Addendum Report 1.0 to 88684-MTP-Bersted-290519-v1.0

88684-MTP-Bersted-291019-Addendum-v1.0

Innovation Centre,
Beeding Close,
Bersted
PO22 9TS

Location:	Innovation Centre, Beeding Close, Bersted PO22 9TS				
Application:	Erection of an industrial building, ancillary to the existing operations				
Prepared for:	JCC Lighting Products Ltd				
Title:	Addendum Report 1.0 to 88684-MTP-Bersted-290519-v1.0				
Project No.:	88684	Date:	29 th October 2019	Issue No.:	1.0
Written By:	T. Smith, BSc (Hons)	Checked By:	E. Bouet, BSc (Hons)	Authorised By:	E. Jeffery, MSci (Hons)

Figure 1: LiDAR Elevation Map (Source: OS, EA)

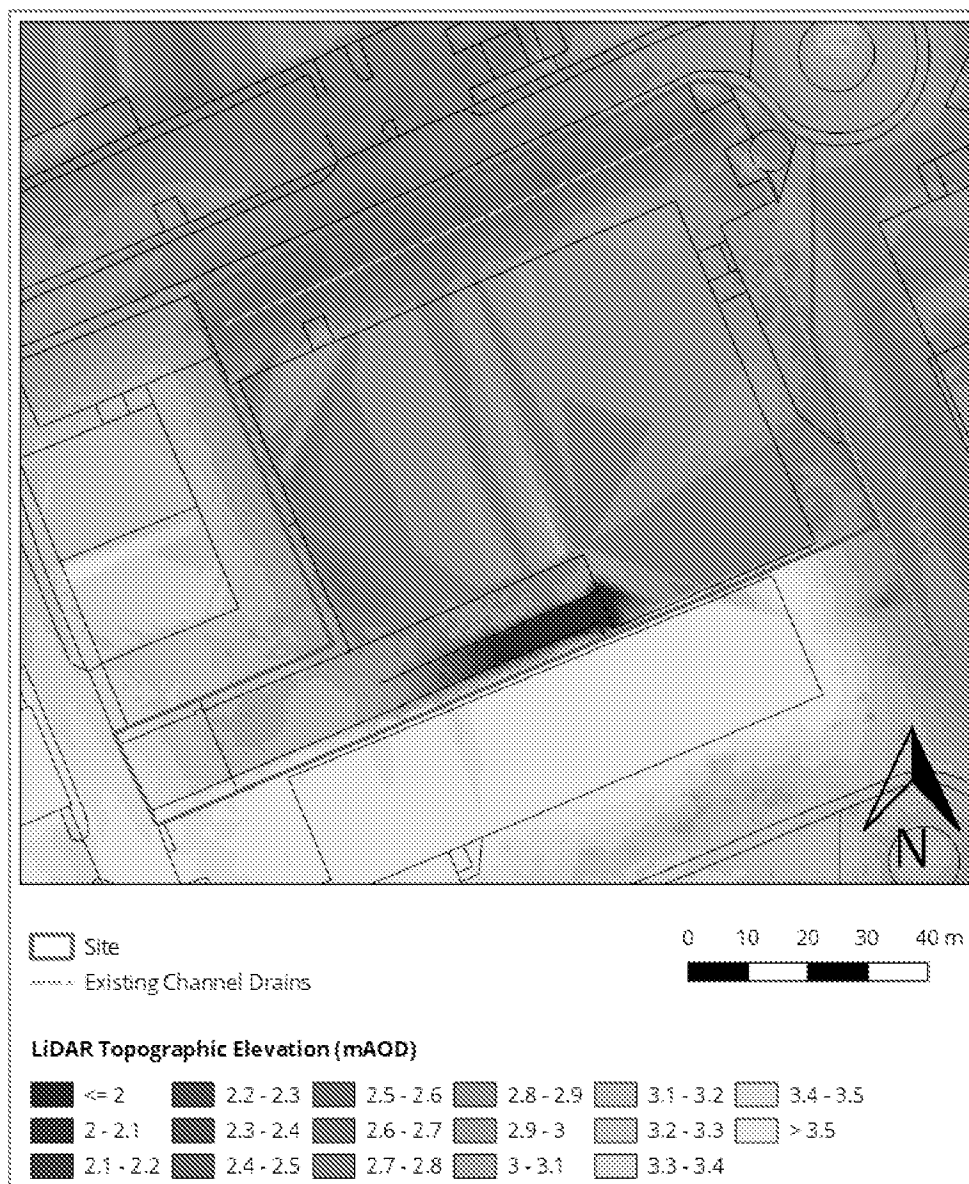
Regarding the levels, I also requested some spot levels of the surrounding land, can these be provided. This is fundamental to ensure that the surface water from the development does not go off site.

Regarding the applicants question as to potential use of LiDAR- LiDAR could be used if it is demonstrated that there is a good correlation between LiDAR levels and the known cover level of the manhole. It may be that the LiDAR elevations aren't particularly accurate due to building shadow effects.

- 2.4. Data suggests that any surface water runoff in the north of the site, associated with the car park area, is currently directed towards and conveyed via an ACO drain to the existing Southern Water surface water network.
- 2.5. The main area of focus in this assessment is the east of the site, associated with land surrounding the new development. According to EA LiDAR information any overland runoff in the loading area, to the east of the main warehouse, would flow in an easterly direction towards a natural topographic depression located along the eastern periphery of the site.
- 2.6. Having reviewed documentation from a site visit, conducted on 13th May 2019, the topographic depression highlighted within EA data correlates to an existing channel drain which runs along the length of the eastern boundary and appears to convey water in a northerly direction (refer to Figure 2).

- 2.7. According to LiDAR information the elevation profile of the neighbouring land, adjacent east and south of the site, slopes down towards the topographic depression along the eastern periphery JCC Lighting Product Ltd. This indicates that any offsite overland runoff would also naturally flow towards the aforementioned channel drain.

- 2.8. The Local Authority have raised concerns that any surface water runoff from the site may impact neighbouring land. In light of the information outlined above, it is considered that any surface water runoff from the east of the site would flow towards the existing channel drain where it would enter the existing surface water drainage network. The channel drain along the eastern boundary appears to be at a lower elevation than the surrounding area therefore data suggests that any overland runoff will not flow off site. Given this, there will be no increased flood risk to neighbouring properties as a result of the development.

- 4.8. Given this, Unda are confident that the EA LiDAR map shown in Figure 1 reflects the natural lay of the land in vicinity to JCC Lighting Products Ltd and post development surface water runoff will not impact the surrounding area.
